UNITED STATES  
DEPARTMENT OF THE INTERIOR  
BUREAU OF LAND MANAGEMENTFORM APPROVED  
OMB NO. 1004-0135  
Expires: July 31, 2010**SUNDRY NOTICES AND REPORTS ON WELLS**  
*Do not use this form for proposals to drill or to re-enter an abandoned well. Use form 3160-3 (APD) for such proposals.*

1. Type of Well <input checked="" type="checkbox"/> Oil Well <input type="checkbox"/> Gas Well <input type="checkbox"/> Other		5. Lease Serial No. NMNM01085
2. Name of Operator CIMAREX ENERGY COMPANY OF CO Contact ZENO FARRIS E-Mail: zfarris@cimarex.com		6. If Indian, Allottee or Tribe Name
3a. Address 600 NORTH MARIENFELD STREET SUITE 600 MIDLAND, TX 79701	3b. Phone No. (include area code) Ph: 432-620-1938 Fx: 432-620-1940	7. If Unit or CA/Agreement, Name and/or No.
4. Location of Well (Footage, Sec., T, R, M., or Survey Description) Sec 23 T19S R30E NENE 1300FNL 695FEL		8. Well Name and No. IRWIN 23-14 FEDERAL 1
		9. API Well No. 30-015-39891-00-X1
		10. Field and Pool, or Exploratory HACKBERRY
		11. County or Parish, and State EDDY COUNTY, NM

Due to rig change we are changing our BOP system for the Irwin 23 14 Fed No. 1 well from a 5K tested to 3K system to a 10K tested to 3K system. 2M div

Exhibit E-1 – Choke Manifold  
Diagram  
Irwin 23-14 Fed 1  
Cimarex Energy Co. of Colorado  
23-19S-30E  
1300 FNL & 695 FEL  
Eddy County, NM

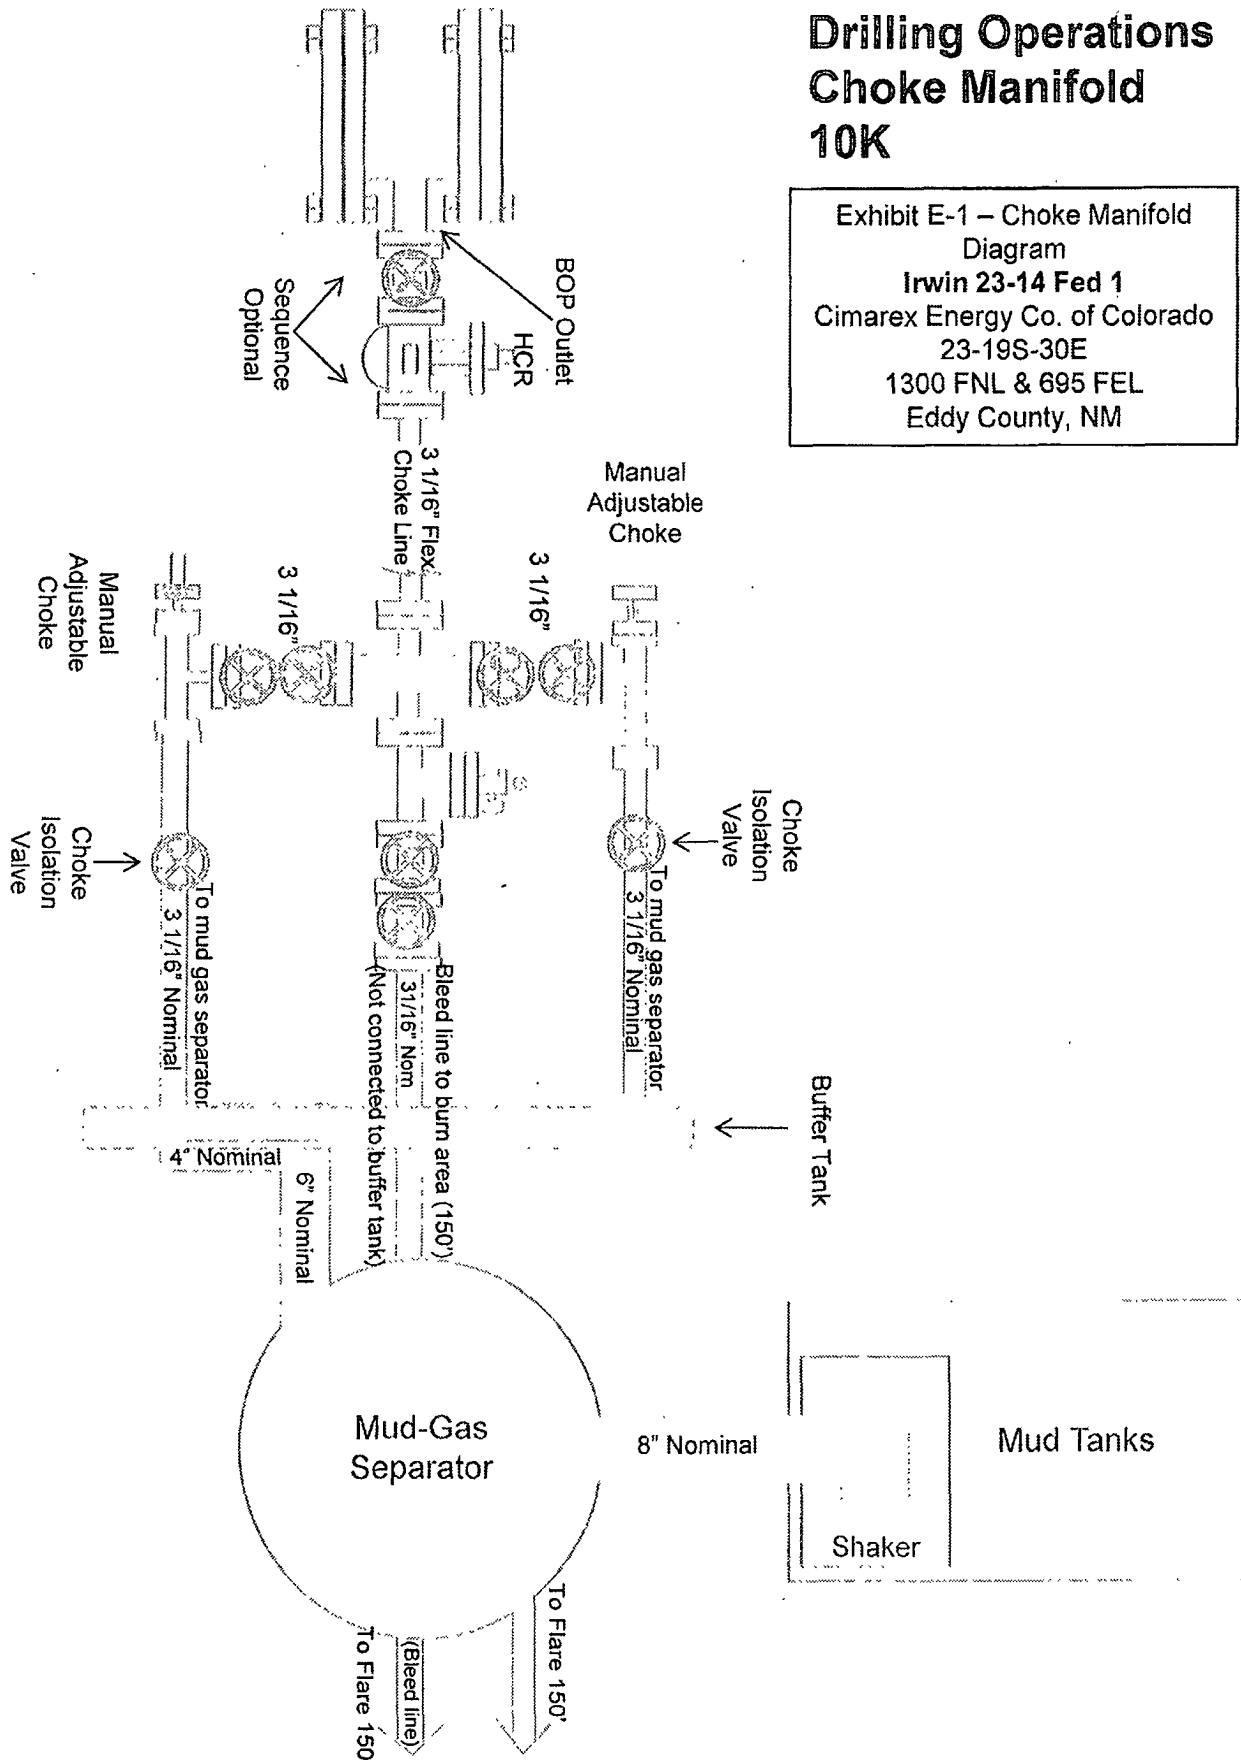
Cimarex Energy Co. of Colorado (operator) requests a variance if Scandril Eagle (rig name) is used to drill this well to use a co-flex line between the BOP and choke manifold.

Variance approved to use flex line from BOP to choke manifold. Check condition of flexible line from BOP to choke manifold, replace if exterior is damaged or if line fails test. Line to be as straight as possible with no hard bends and is to be anchored according to Manufacturer's requirements. The flexible hose can be exchanged with a hose of equal size and equal or greater pressure rating. **Anchor requirements, specification sheet and hydrostatic pressure test certification matching the hose in service, to be onsite for review.** If the BLM inspector questions the straightness of the hose, a BLM engineer will be contacted and will review in the field or via picture supplied by inspector to determine if changes are required (operator shall expect delays if this occurs).
